OCONEE NUCLEAR STATION, UNIT NO. 1

AMENDMENT TO FACILITY OPERATING LICENSE

Amendment No. 37
License No. DPR-38

ATTACHMENT TO LICENSE AMENDMENTS

FIGURE 2.1-2A

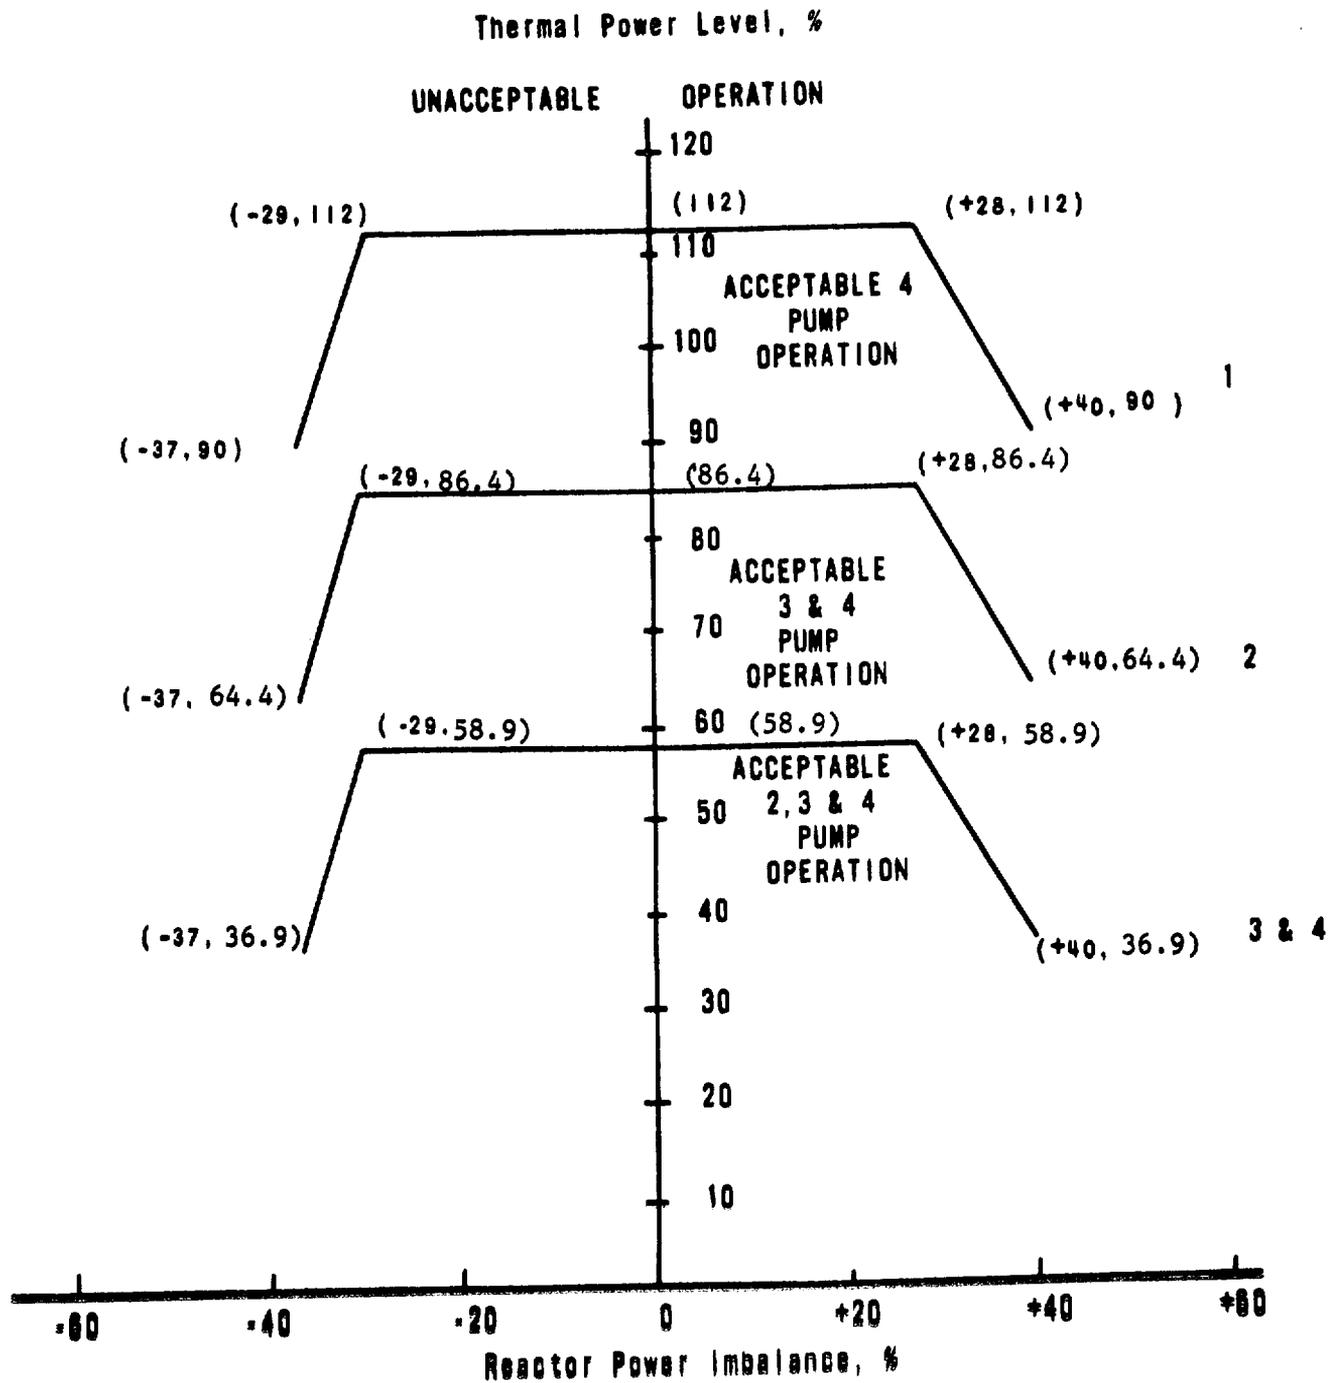
The specified flow rates for Curves 1, 2, 3 and 4 of Figure 2.1-2A correspond to the expected minimum flow rates with four pumps, three pumps, one pump in each loop and two pumps in one loop, respectively.

The maximum thermal power for three-pump operation is 86.4 percent due to a power level trip produced by the flux-flow ratio 74.7 percent flow \times 1.07 = 79.9 percent power plus the maximum calibration and instrument error. The maximum thermal power for other coolant pump conditions are produced in a similar manner.

These amendments will increase the flux/flow trip setpoint of the Reactor Protective System for Unit 1 from 1.055 to 1.07. This increase results from the elimination of the reactor internals vent valve flow penalty.

FIGURE 2.3-2A

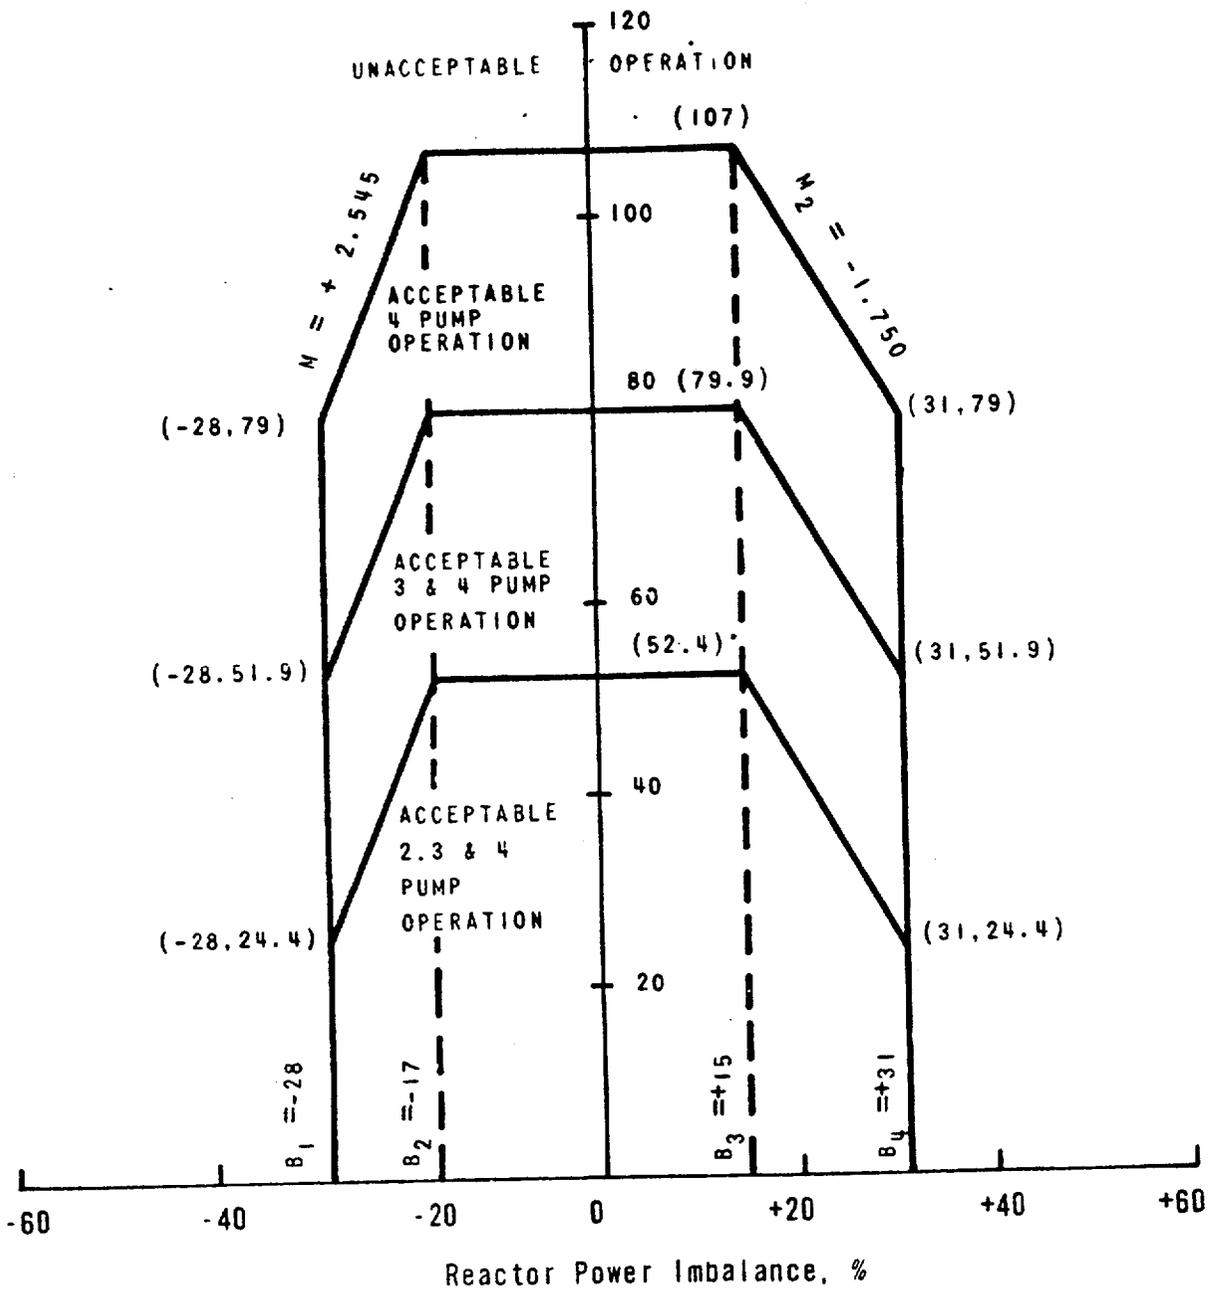
The power-imbalance boundaries are established in order to prevent reactor thermal limits from being exceeded. These thermal limits are either power peaking kw/ft limits or DNBR limits. The reactor power imbalance (power in the top half of core minus power in the bottom half of core) reduces the power level trip produced by the power-to-flow ratio such that the boundaries of Figure 2.3-2A - Unit 1 are produced. The power-to-flow ratio reduces the power

level trip and associated reactor power/reactor power-imbalance boundaries by 1.07% for a 1% flow reduction.
